FINAL FINDINGS AND DECISION BY THE DESIGN COMMISSION RENDERED ON October 22, 2015

**CASE FILE NUMBER: LU 15-169591 DZM AD MS
PC # 15-120750**

NW 11TH & HOYT

BASEMENT & GROUND FLOOR PLAN | C.27

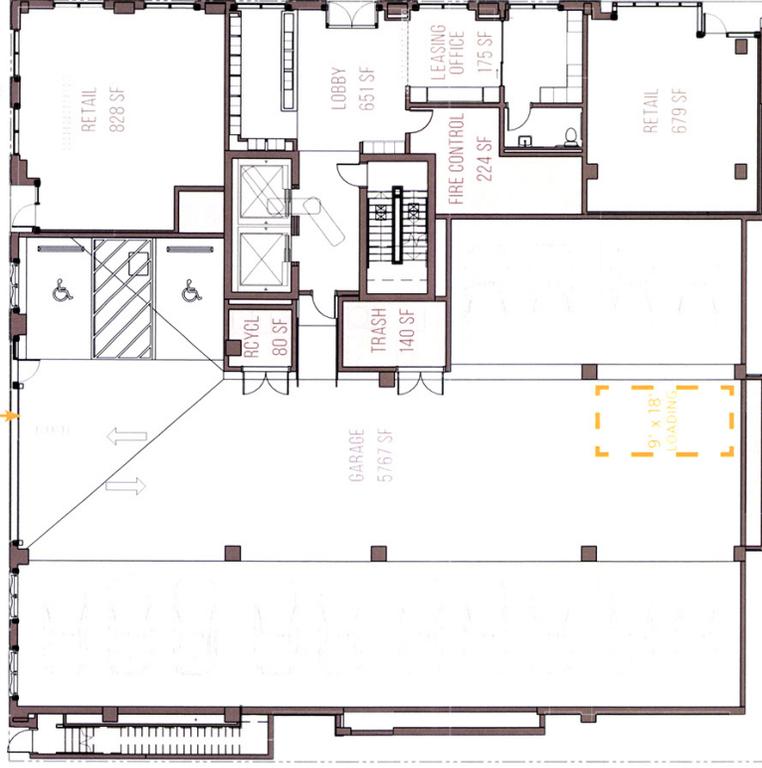
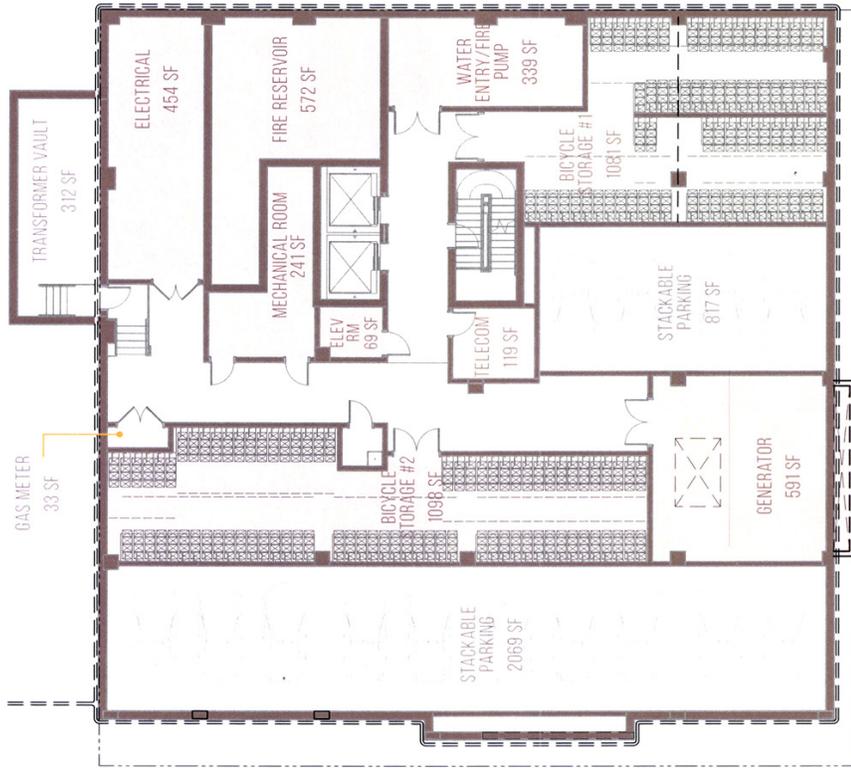
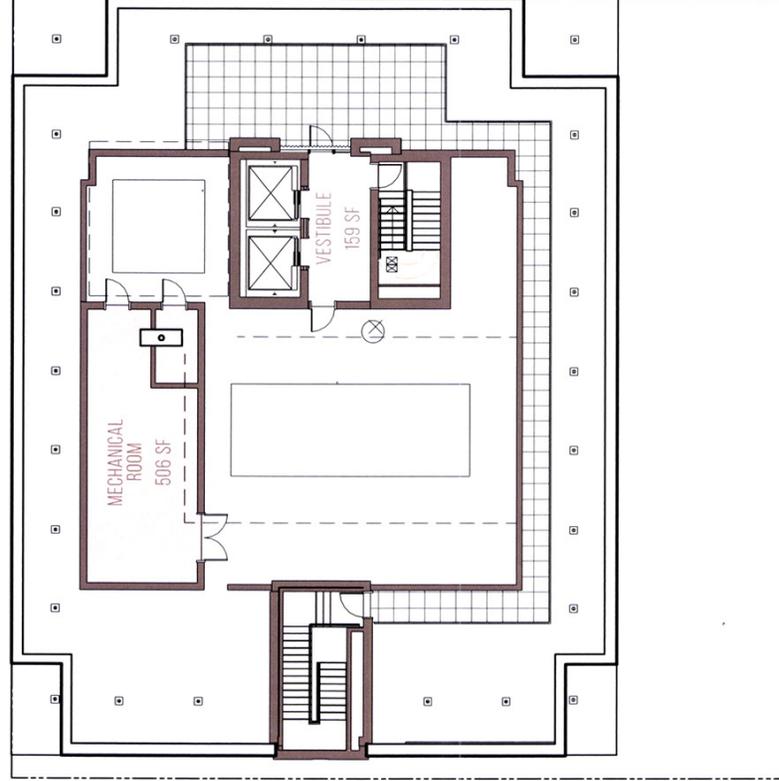
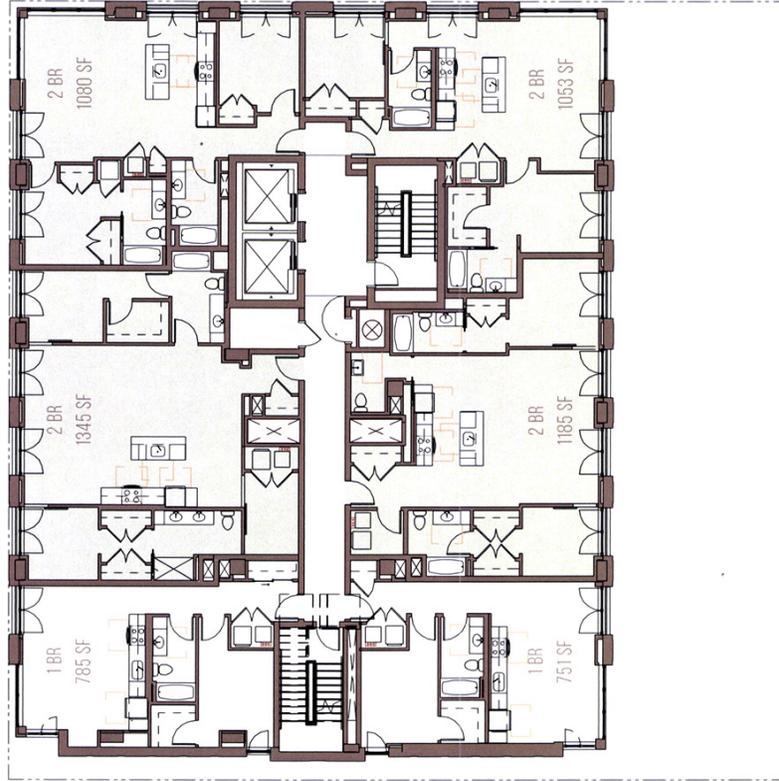
Findings: The 9' wide x 18' long loading space is proposed to occur within the drive aisle, which effectively reduces the 22' width of the drive aisle in half and blocks access to a small portion of the parking spaces. The purpose of the parking related development standards of Section 33.266.130.A are stated below and the portion italicized are applicable to the Modification requested:

The applicant has adequately demonstrated that the transportation-related approval criteria relative to the requested Adjustment for the single small loading space and Modification for loading to occur within the drive aisle are satisfied. PBOT is supportive of both requests. Allowing the loading to occur within a drive aisle allows for more efficient use of the ground floor and more active uses along the pedestrian realm, better meeting Central City Design Guideline A8 (Contribute to a Vibrant Streetscape). *The approval criteria have been met.*

SOUTH ELEVATION

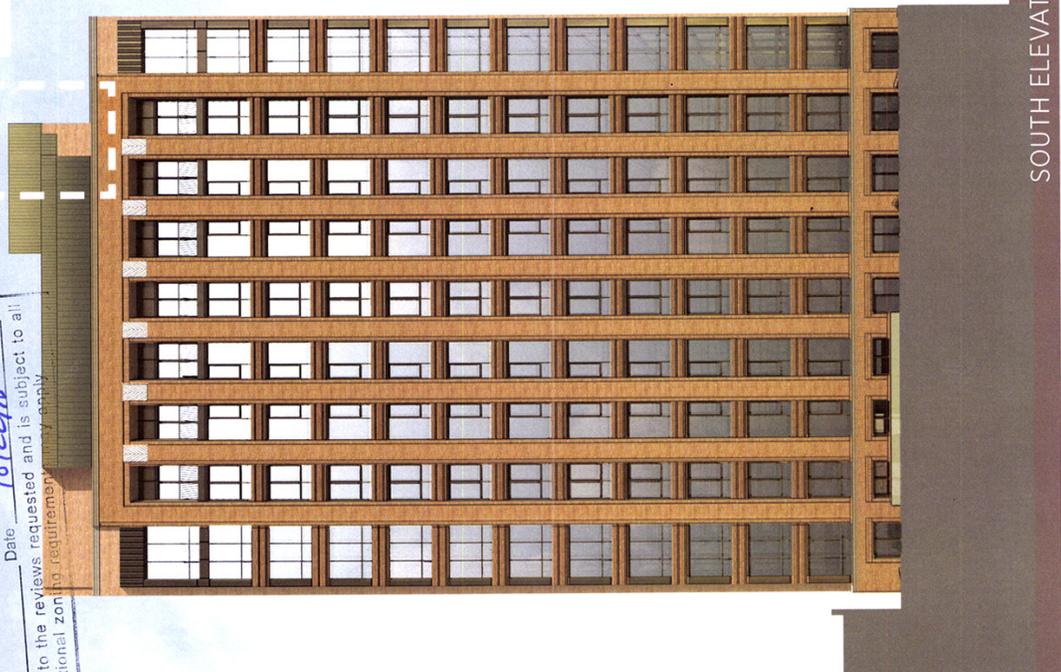
The other significant design concerns raised at the hearing included the need to design and consider all four facades and not just focus on the two facing the street. The ground floor along Hoyt also was noted as needed some attention, which is discussed in detail in Section 2 (Modifications) of this report below. The revisions to building facades have been very responsive and include extending the decorative precast panels to the upper floor facades of the south and north elevations and increasing the amount of brick and detailing on the west end wall. The center bay of metal panel on the west end wall was replaced with brick and extended up to the roof to capture the stair enclosure. Brick reveals were also added in a design that accentuates the verticality of the building and complement the strong vertical columns on the other three facades.
